Access Report on Entrances and Facilities at Brecon Cathedral

24 May 2022

JANE TOPLIS ASSOCIATES LTD

BRECON CATHEDRAL: ACCESS REPORT ON ENTRANCES AND FACILITIES

Outer double doors, with a raised threshold with one step up and two steps down inside

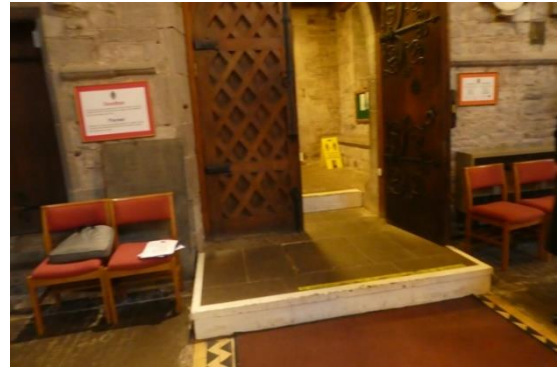
In detail the porch has a 125mm high step up to the external double doors (860mm clear width). Just inside these doors there are two steps (risers of 150mm and 170mm height) down into the porch.

None of the porch steps have handrails and the painted contrasting nosings on some steps are worn away.

- *Resurface tarmac path through churchyard so that there is a smooth surface.*
- *In the short term the contrasting nosings on some steps should be repainted.*
- *In their current arrangement the North Porch steps present a trip hazard for ambulant disabled and visually impaired people, due to their irregular dimensions and the low lighting levels. A design study is required to see if there are any possible locations to mount handrails, taking into account the confined space within the porch and the steps' proximity to the door swings.*

Flagstone path to accessible door into vestry range

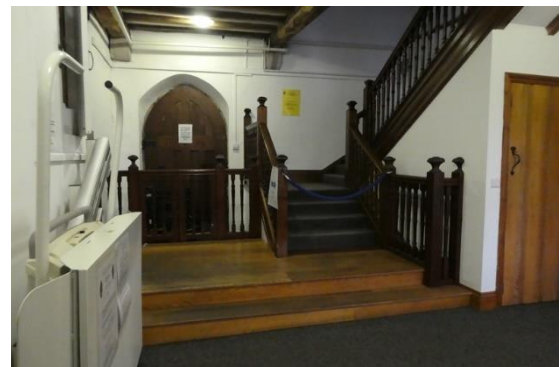
Just beyond the speed bump there is a reasonably level flagstone path to the South Door into the Vestry Range. This is a level doorway with 1050mm clear width. The door is heavy to push/ pull and the ironmongery is difficult for somebody with limited dexterity to open.

- *In the short term the South Door into the Vestry should have its door closer adjusted to reduce the opening force in accordance with AD M 3.10a.*
- *In the short term handrails should be mounted on the two steps in the Vestry and more visible contrasting nosing strips are required on the step edges.*

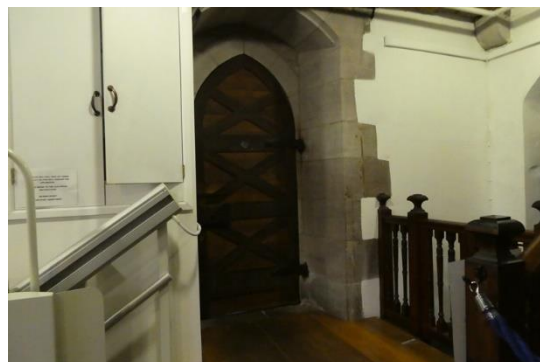
Inside this doorway there is a reasonable spacious level area and then two steps up to a small landing at Nave level. These two steps (130mm risers and 290mm goings) have no handrails.

An incline platform lift has been installed to rise up these two steps. A member of staff must be summoned to operate it, so it is not an unassisted means of access.

Wheelchair users find incline platform lifts awkward and undignified to use. Many people will refuse to use them. They are also slow and can often break down. This is not an acceptable accessible entrance route into the Cathedral, especially as wheelchair users have to take a long detour from the main North Porch entrance. While on site I was informed that it is very rarely used.

- *A design study is required to establish the best location for an inclusive accessible entrance (for able bodied people and wheelchair users) into the Cathedral, avoiding the awkward steps at the North Porch entrance and the very poor wheelchair route into the Cathedral through the Vestry Range. Section 3 discusses different entrance options.*

South Aisle Door has no space for a wheelchair user to manoeuvre and open the door independently

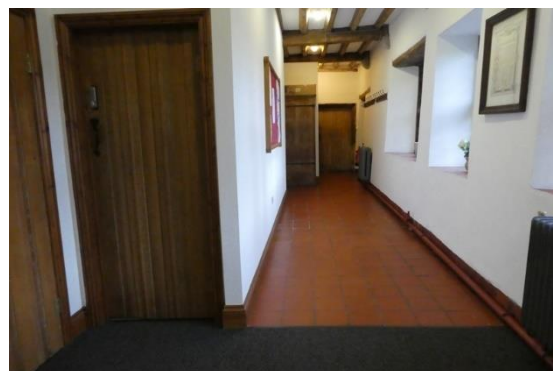
The final access barrier on the 'wheelchair accessible' route is the door from the Vestry Range into the Cathedral's South Aisle. The door (860mm clear width) is approached from the narrow landing at the top of the two steps discussed in section 2.1.5 above. It is positioned within a deep alcove through a thick wall. The offset at the leading edge of the door leaf is less than the required 300mm and the wheelchair manoeuvring space is constricted by the top step edge, the metal track of the incline platform lift and a balustrade.

The door is either left open when the Cathedral is open to the public, or staff have to open it for a wheelchair user to pass through, because of this lack of manoeuvring space.

- *The South Aisle Door opening from Vestry Range should be automated, or the doorway widened. This door is discussed in Section 3 Option 11.*

Approach to accessible WC door is obstructed by cupboard and has small high sign

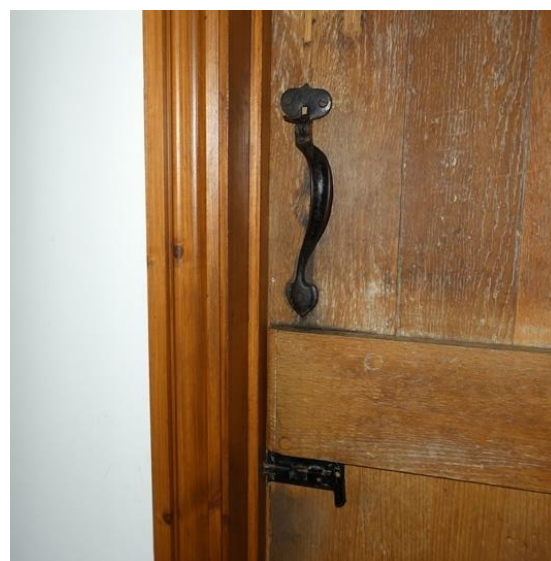
The unisex wheelchair accessible WC cubicle is reached from a reasonably wide lobby area and has an outward opening door (980mm clear width). The large cupboard in the lobby slightly obstructs wheelchair circulation in front of the WC door.

- The wheelchair symbol on the door is too small and is mounted at high very level. The baby changing symbol mounted just below it is more visible.
- The wrought-iron ironmongery on the door is not openable by someone with limited dexterity and is at very high level (1325mm afl) with a small pull handle below it. The requirement is that door ironmongery should

- *The door signs on the unisex wheelchair accessible WC cubicle door should be larger to assist people with vision impairments, and mounted at maximum 1200mm height suitable for wheelchair users.*
- *The wrought-iron door ironmongery should be replaced with door handles at 900mm afl. The door handles and controls should be able to be operated with a clenched fist and the door should be openable from the outside, if somebody falls within the cubicle.*
- *A horizontal grabrail should be fixed on the inner face of the door at 900mm afl.*
- *The baby changing unit should be mounted at 850mm afl.*

Door ironmongery is not openable by someone with limited dexterity

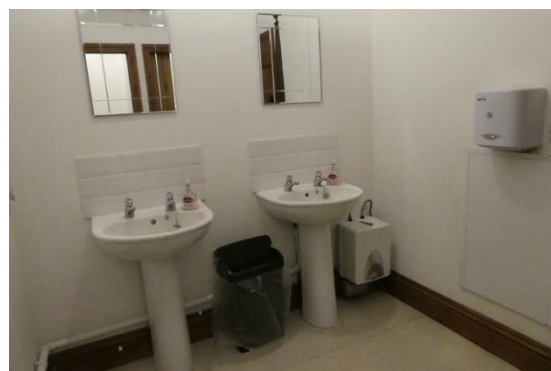
be able to be operated by someone using a clenched fist. Inside there is a small, awkward sliding bolt to secure the door. This bolt is mounted at a reasonable height (945mm afl) but cannot be opened from the outside, if somebody falls within the cubicle.

- There is no horizontal grabrail fixed on the WC cubicle door.
- The baby changing unit is mounted at a high level (1026mm afl).
